# Wylfa Newydd Project

## Horizon's Response to Written Representation - Natural Resources Wales

PINS Reference Number: EN010007

18 December 2018

0.61 – 1mg/L = 88.5017ha

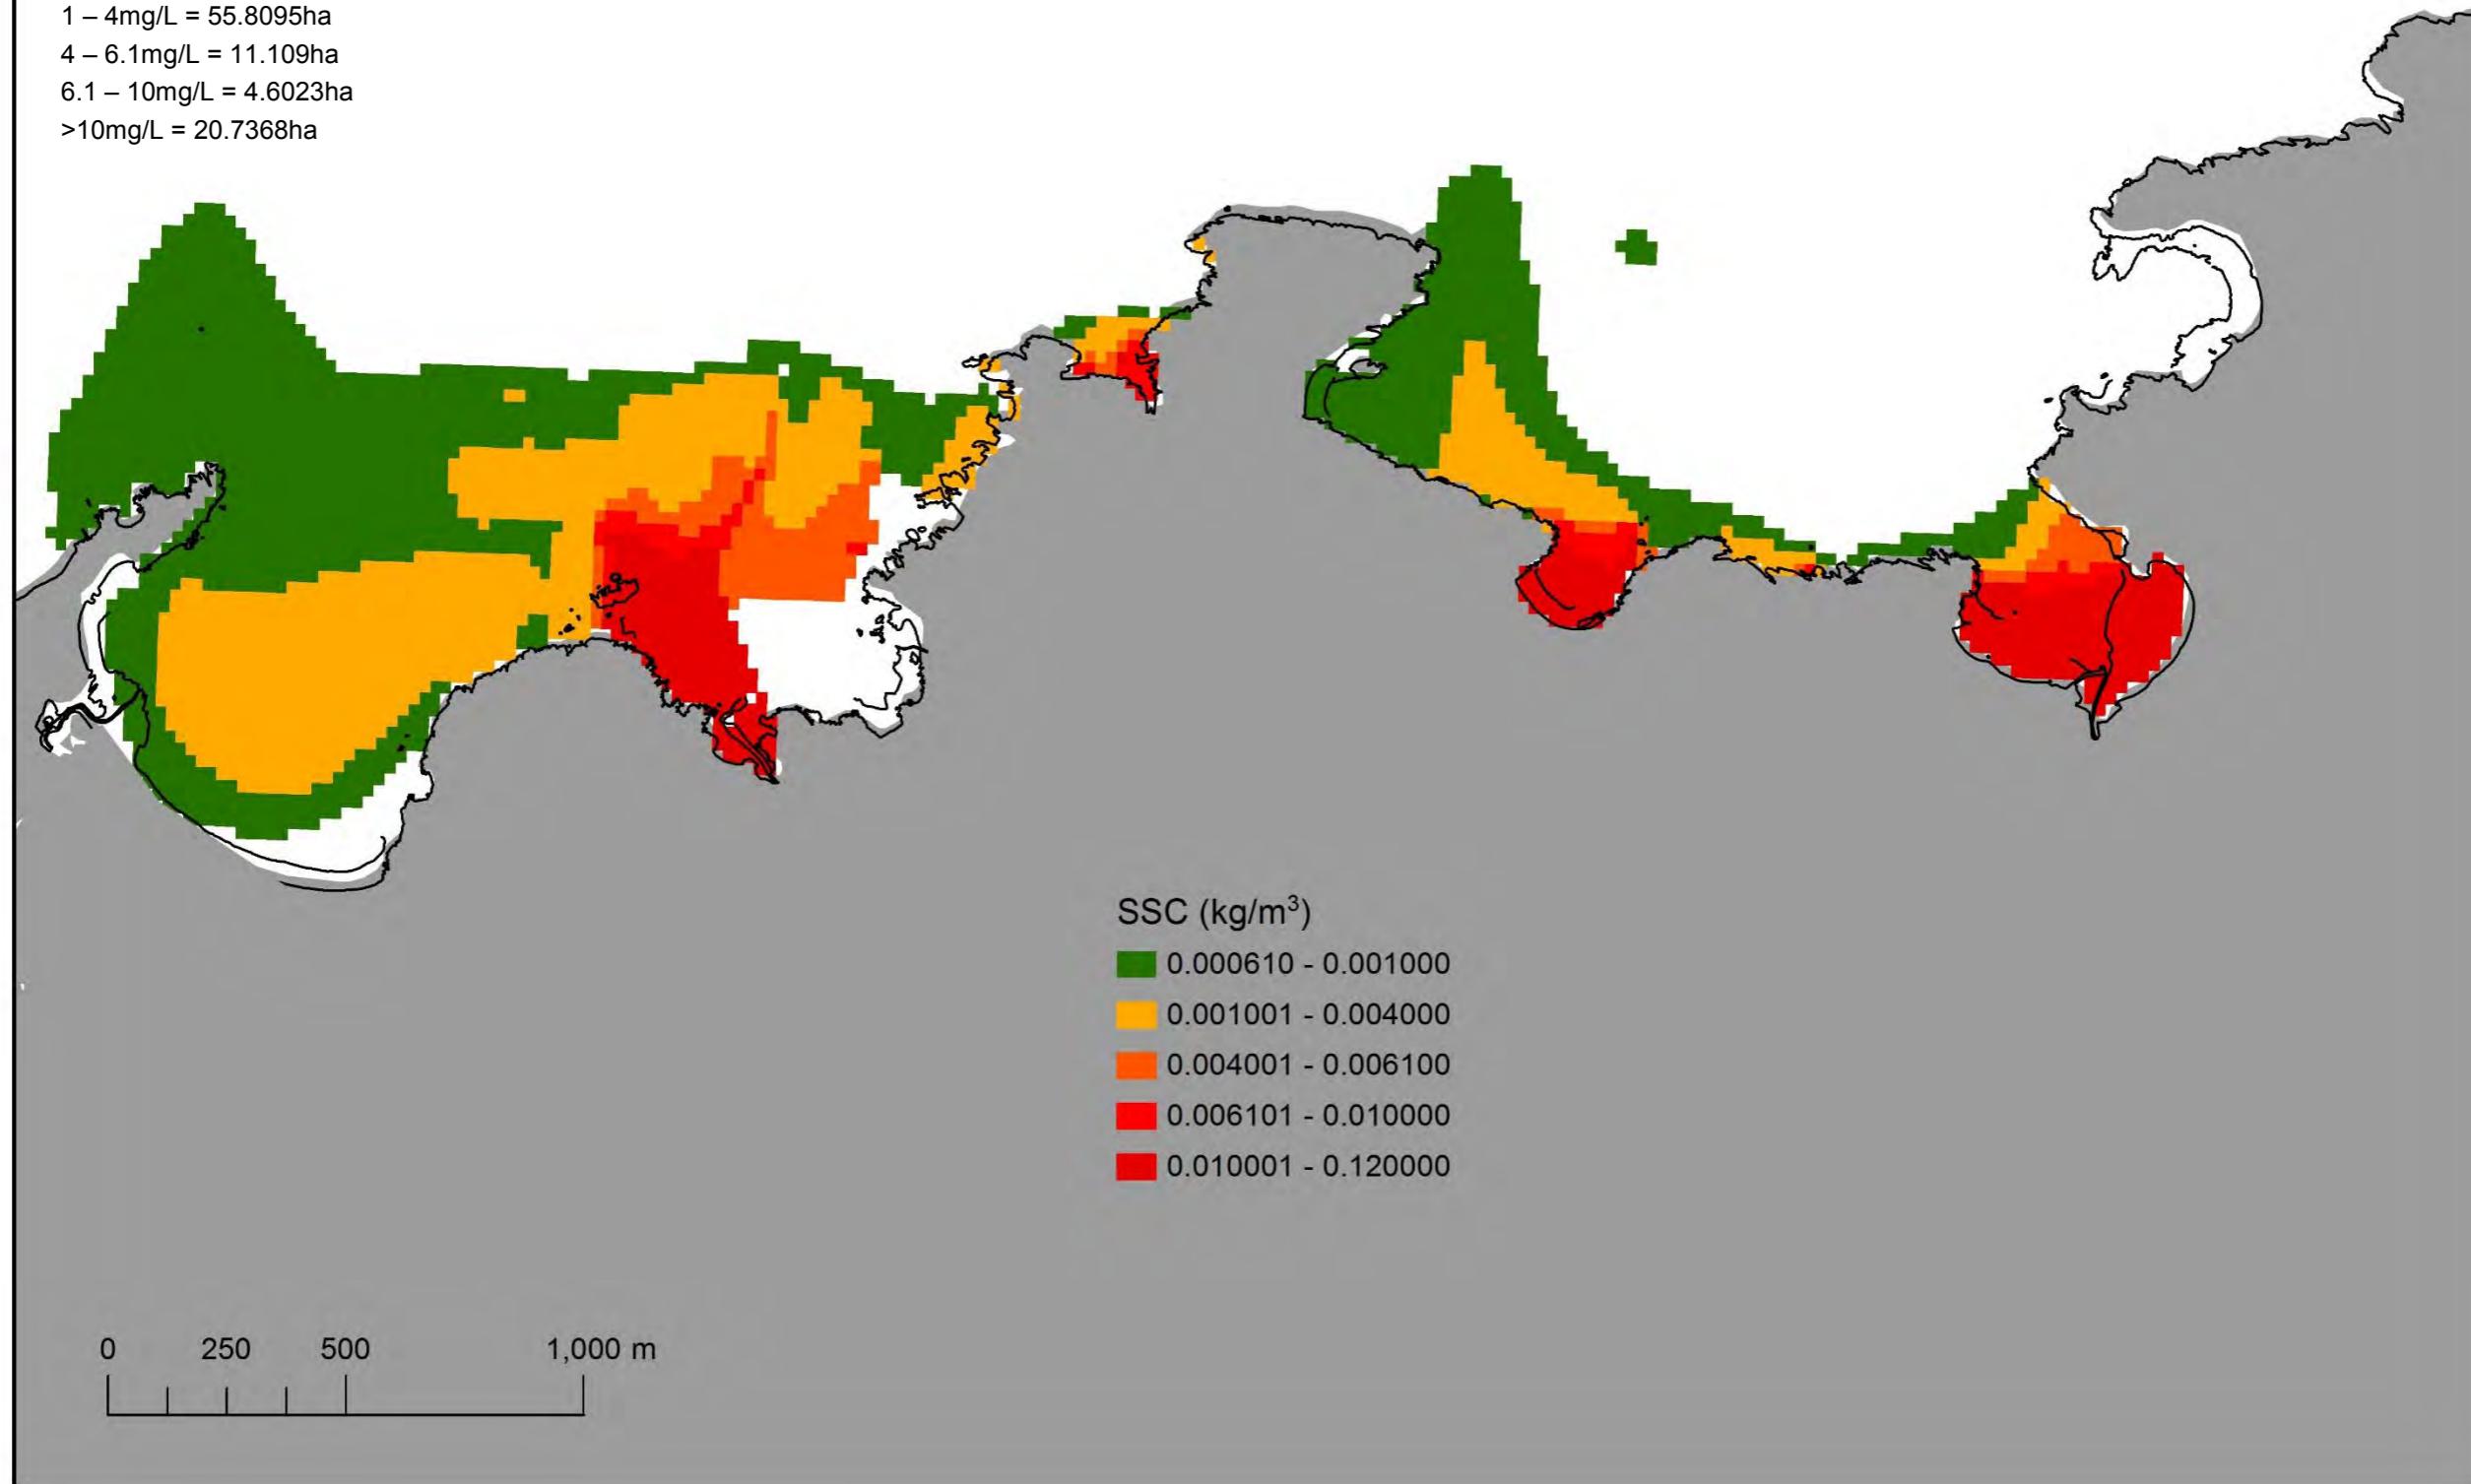
7.30.21 As agreed with NRW in the context of discussions regarding the Environmental Permit application, Horizon has prepared revised figures and recalculated the areal extent of change above a 10% background (0.61mg/L total suspended solids loading) as agreed. This data is provided in Appendix A to this document. The total suspended solid plots presented in figures 164; 165; 166; 169 & 170 in appendix D13.08 [APP-226] show the increase in suspended solid concentrations for the Wylfa Newydd DCO Project. These plots have been updated in Appendix A to show suspended solid increases above 10% of background (i.e. >0.61 mg/L total suspended solids) and areal extent.

Figure 1 Reactor building profile

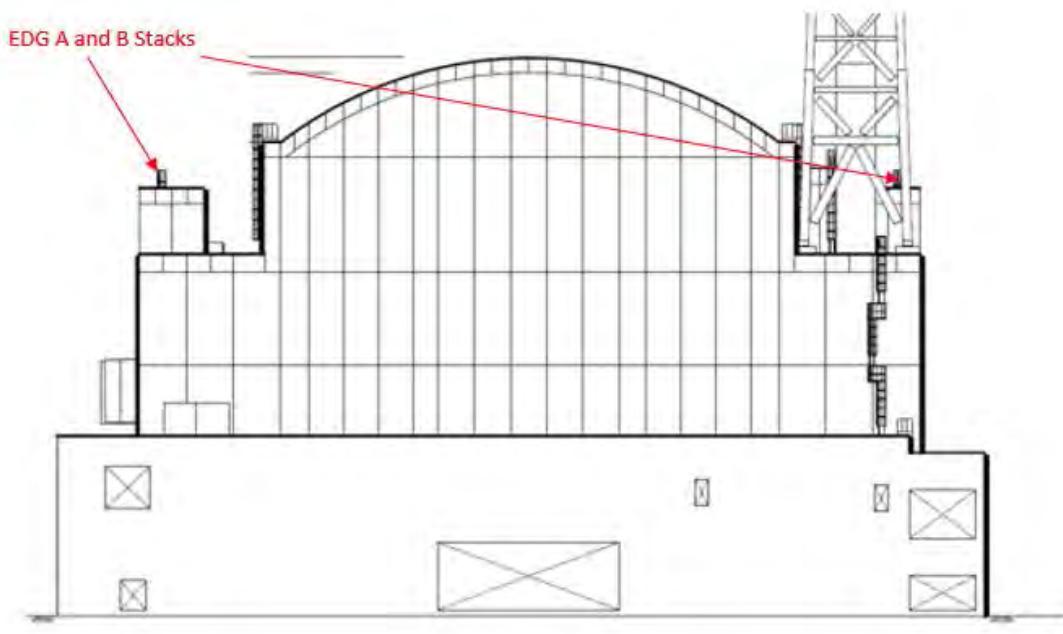
The reactor buildings (1-101 and 2-101) are the only modelled buildings which do not have flat roofs. The reactor building is a tiered building arrangement with a domed roof. EDGs A and B are installed in buildings immediately adjacent to the reactor building. However, due to this proximity, it is possible to route their stacks up the side of the reactor building, using the reactor building walls as support. It is not possible to do so for Unit 1 and Unit 2 EDG C since these EDGs are installed in a building which is a greater distance from the reactor building.

The stacks for EDGs A and B discharge 3 m above a parapet on the second tier of the reactor building, resulting in the stacks discharging approximately 4 m below the apex of the reactor dome (the top of the parapet is 7 m below the apex of the dome). Figure 1 visually depicts the tiered structure of the reactor building and the location of the stacks for EDGs A and B.

This arrangement does present certain challenges for the modelling assessment since, due to the number of other buildings included in the model, it is not possible to model each tier of the reactor building without exceeding the maximum number of buildings allowed by the model. Furthermore, the dispersion model can only model flat roofs. Consequently, certain simplifications to the building and stack representation in the model have been made by necessity, such as modelling the reactor building as a single tiered, flat roof building. However, where simplifications have been made, these aim to produce a more conservative estimate of the resulting impact.

Figure 2 Visualisation of various modelled reactor building and discharge location options

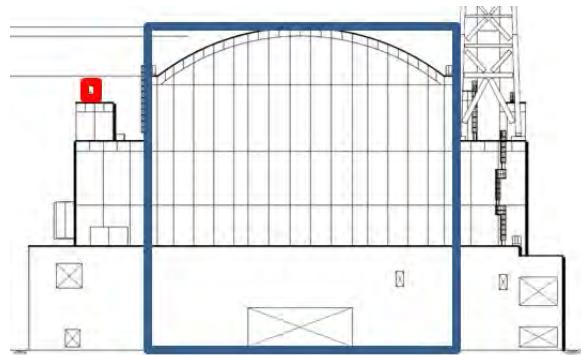
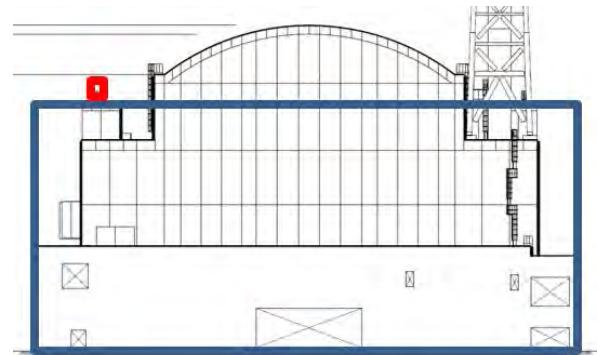
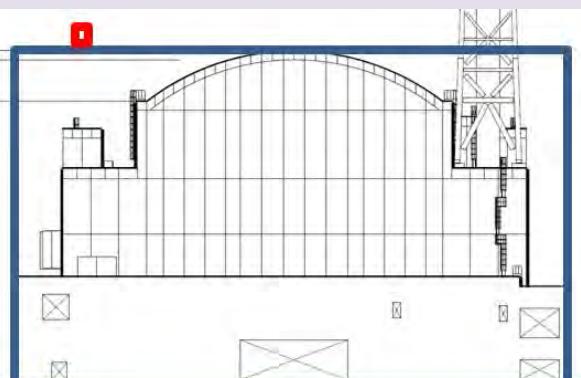
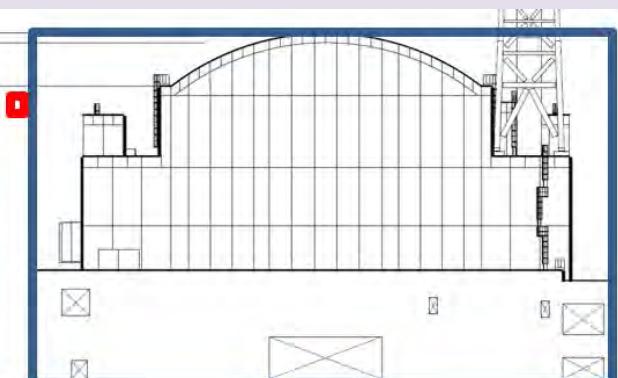
With the assumption of a single tiered building, a scenario needs to be avoided whereby the stack(s) discharge within the building itself, since the model will not run where this is the case. Consequently, various options were considered to represent the reactor building and discharge points for EDGs A and B in the model. These options can be visualised in Figure 2.

- Option 4: EDG discharge location moved such that it is immediately adjacent to the modelled building, EDG discharge height modelled as 3 m above the parapet level, reactor building height modelled as the dome apex height, reactor building width taken as the width of the bottom tier.
